**TG08.7 – Glass Floors**

<b>Question No.</b>	<b>Submission Date</b>	<b>Drawing No.</b>	<b>Document/ Spec. No.</b>	<b>Question</b>	<b>Response</b>
TG08.7-003	2/17/2015	A1-2705	00 04 41 Pre-Bid Substitution Request 08 88 53	Please review the attached form 00 04 41 - Pre-Bid Request for Substitution.	Due to lack of current UL rating report, the system does not meet the specification requirements. The substitution request is rejected. Please refer to the attached comments on technical issues found within the information provided.

Spec. Section: 08 88 53 GLAZED FLOORS Date: 2/16/2015  
 Drawing Sheet: A1-2704, A1-2705, A1-2305 Paragraph(s): 2.2  
 Detail(s): W-12 & W-13

## 120 MIN. FIRE-RATED FLOOR

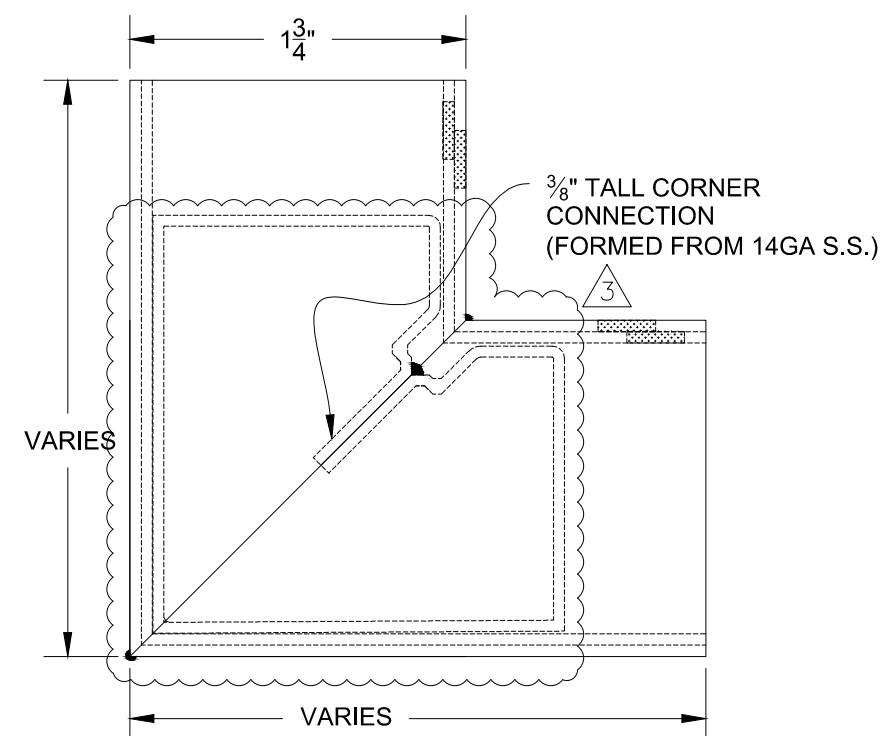
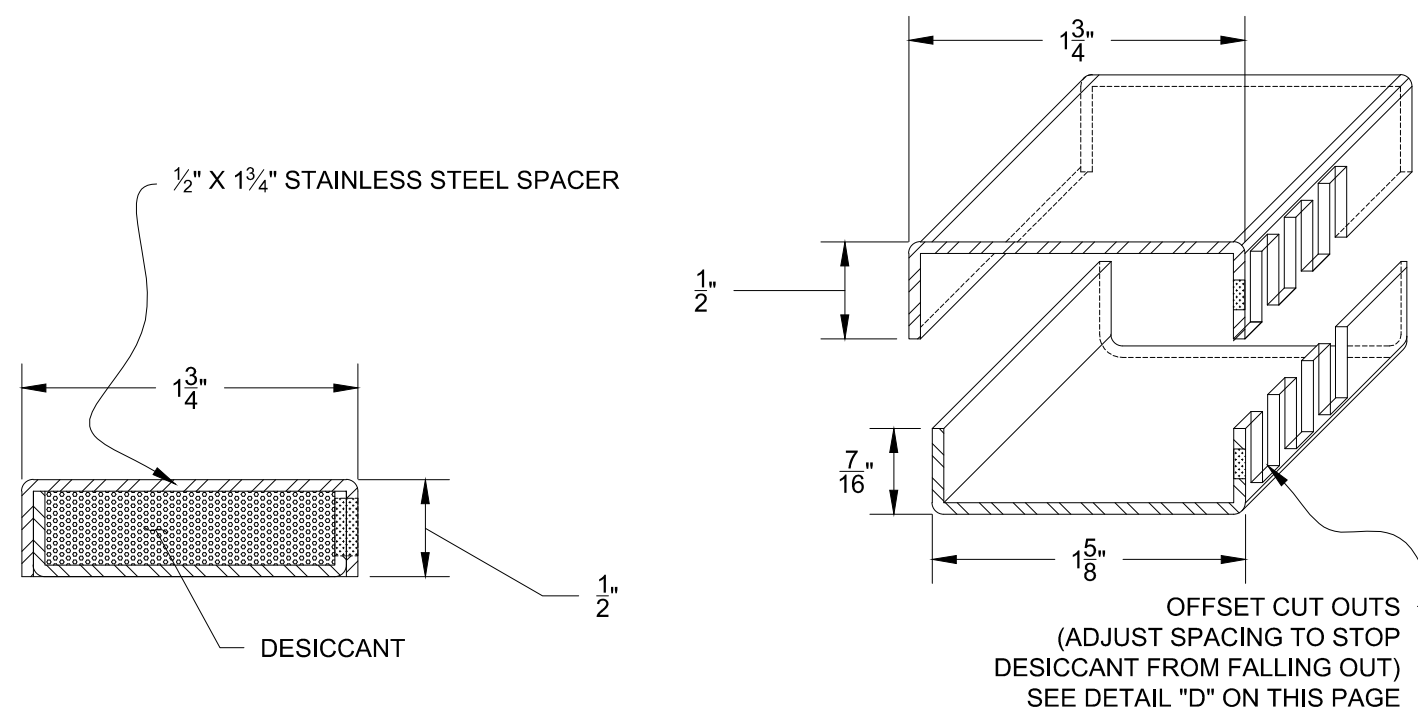
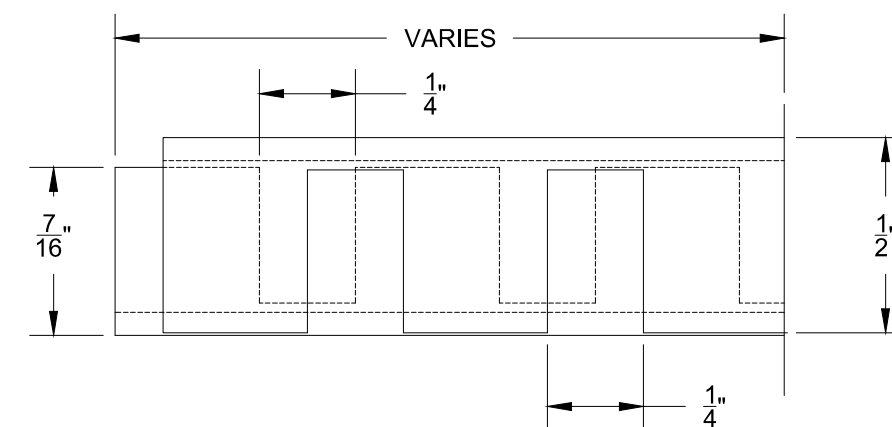
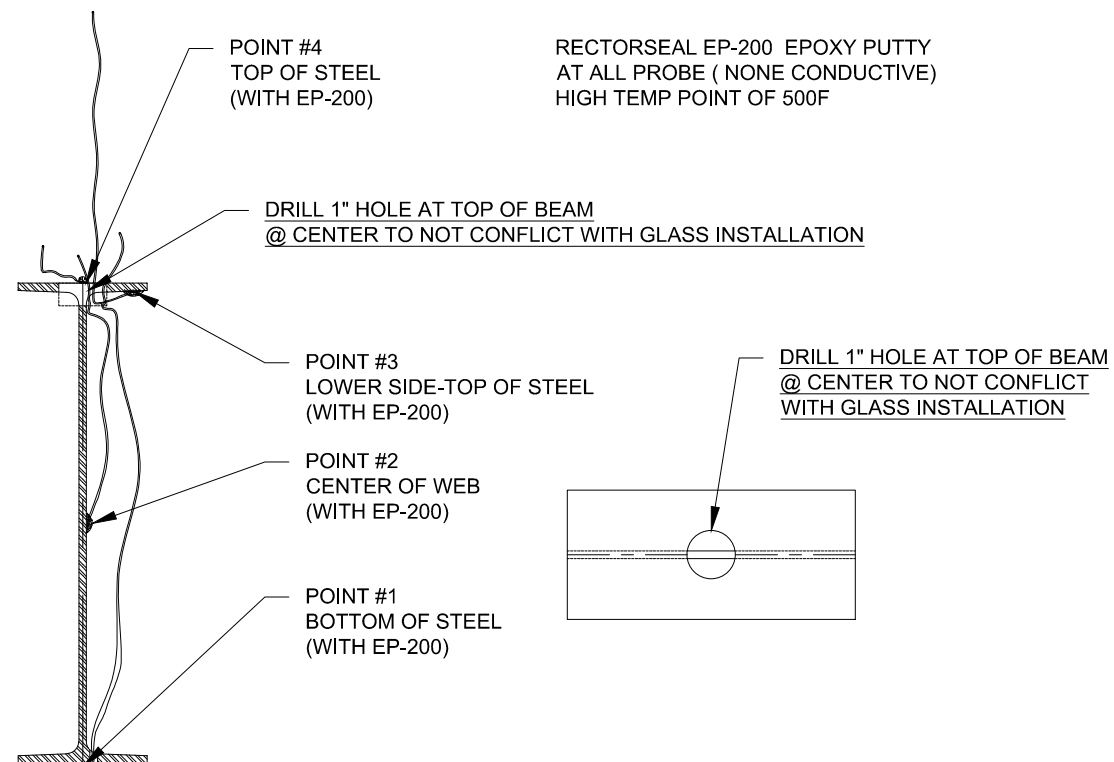
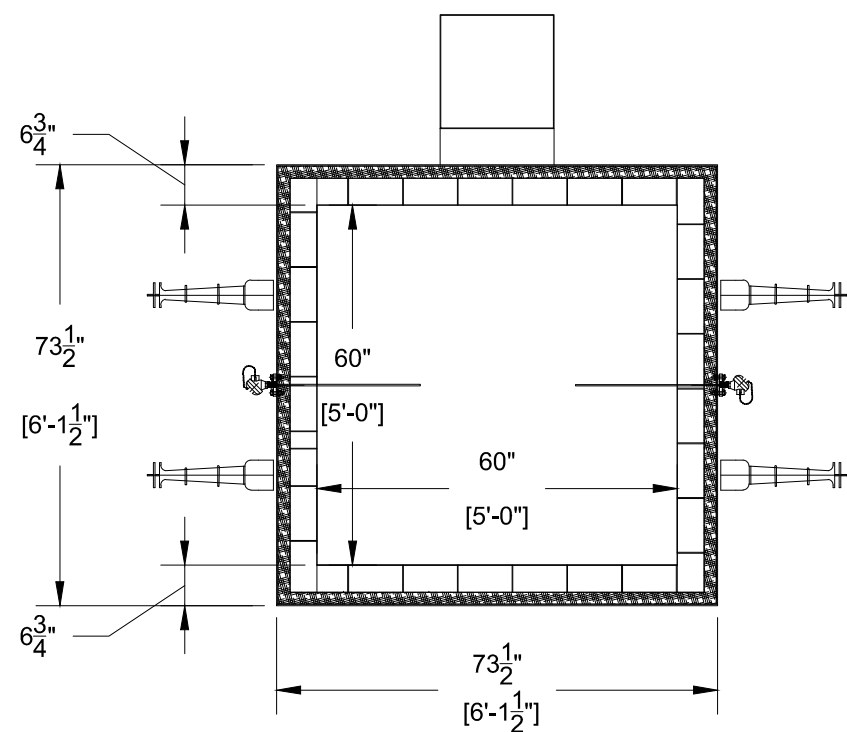
If tested, provide UL Design. SFFD/DBI will not accept Intertek Listing alone
